MPC Paper No. 13/15

For Consideration by
the Metro Planning Committee on 20.11.2015

FURTHER CONSIDERATION OF THE
DRAFT PLANNING BRIEF FOR THE
FIVE “COMPREHENSIVE DEVELOPMENT AREA” ZONES AT
TUNG YUEN STREET AND YAN YUE WAI, YAU TONG

圖 PLAN
 5

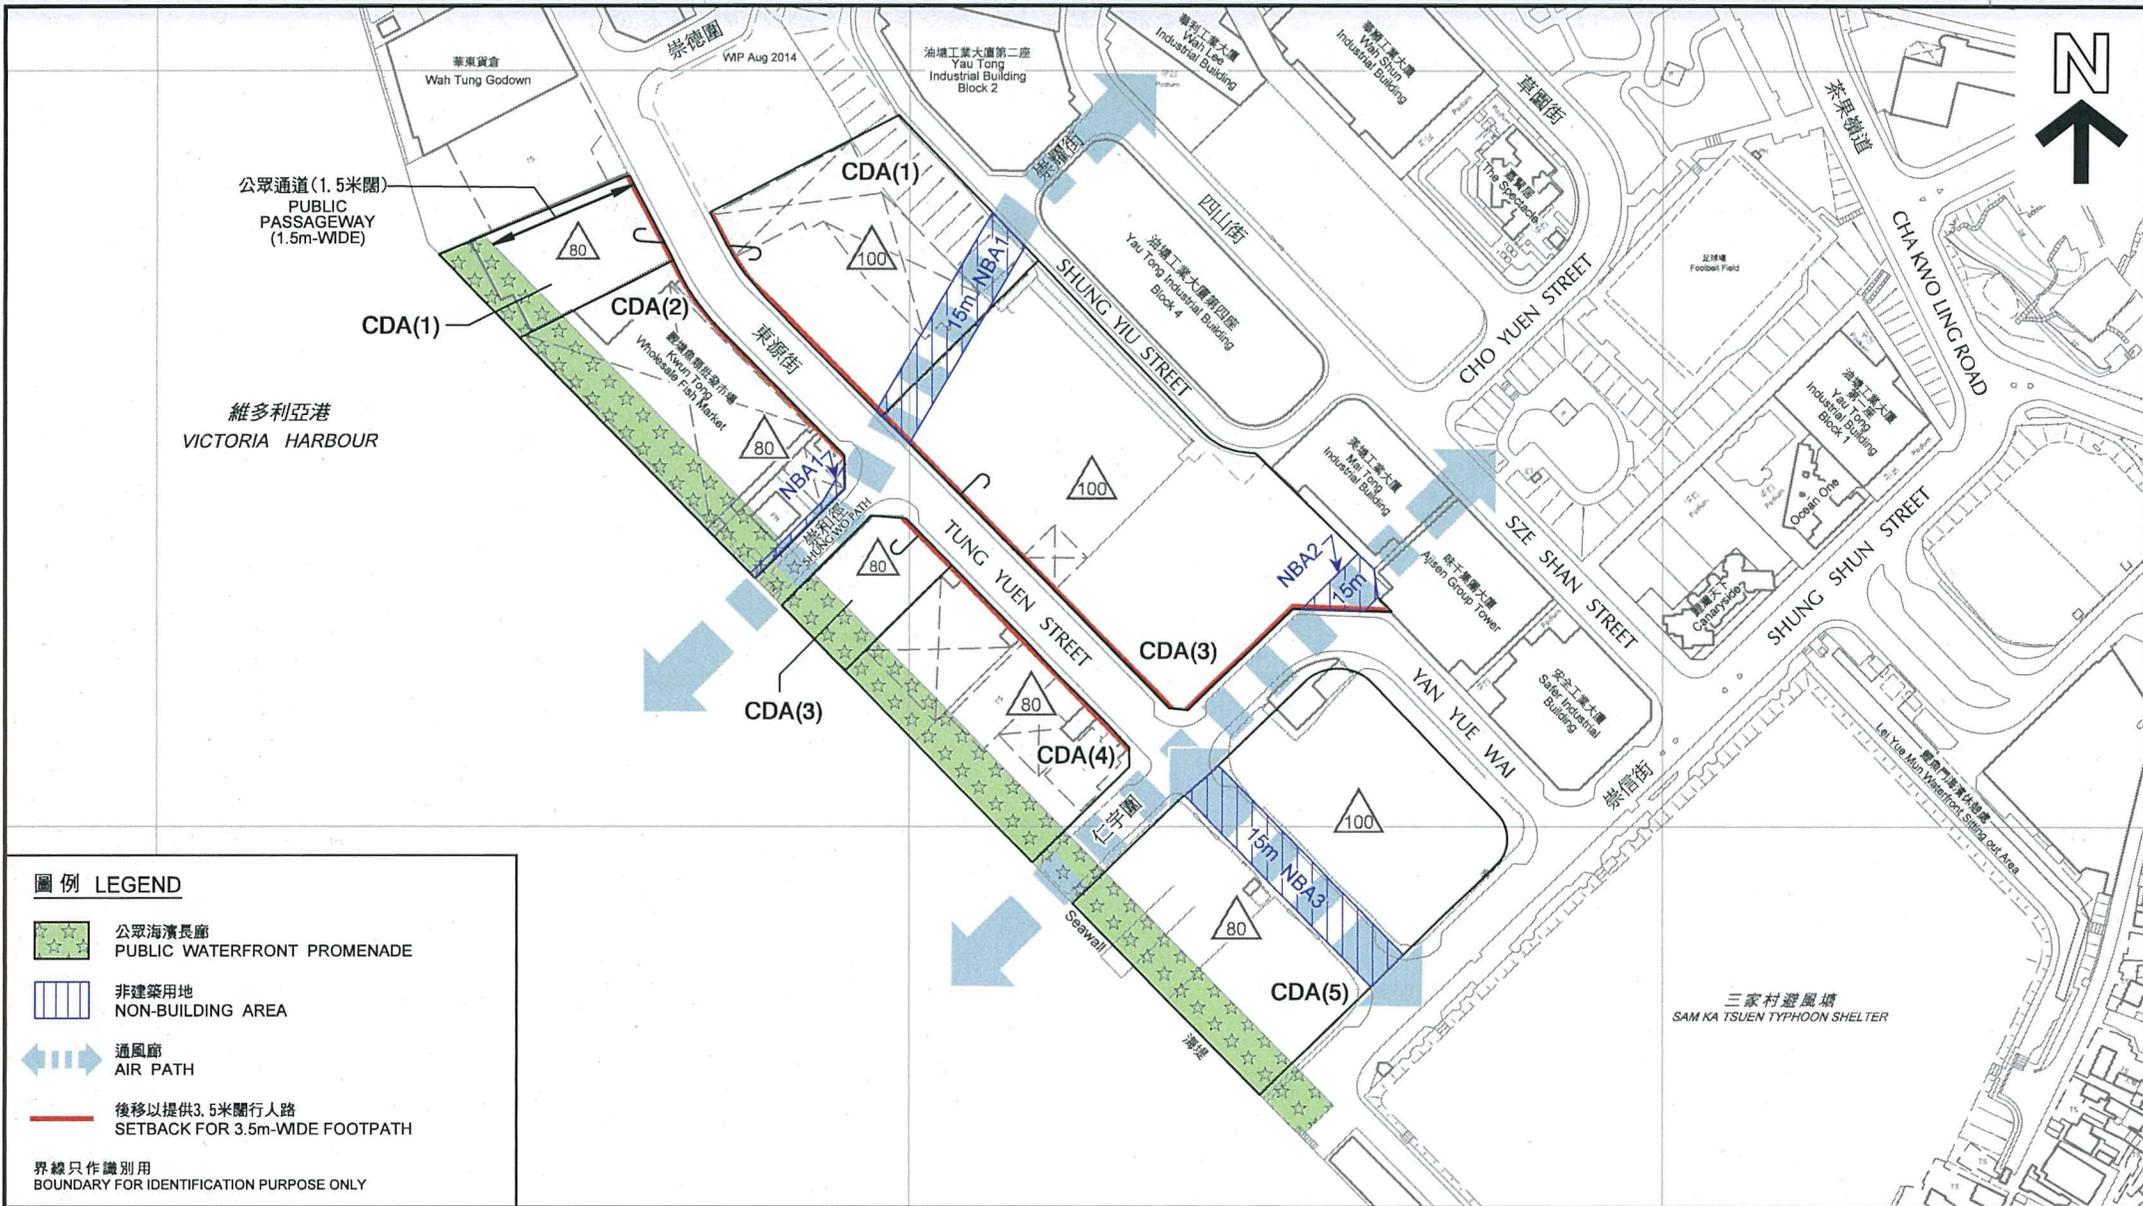
- 4.12 Pedestrian streets: the south-western ends of Shung Shun Street, Yan Yue Wai and Shung Wo Path would form part of the promenade upon full development of the five “CDA” sites (**Plan 5** of Appendix I). The remaining section of the streets will need to be retained for traffic circulation and access to individual sites. To facilitate pedestrian circulation in the area, the PB has stipulated that the developments along Tung Yuen Street and north-western side of Yan Yue Wai has to be setback to provide a 3.5m wide footpath.
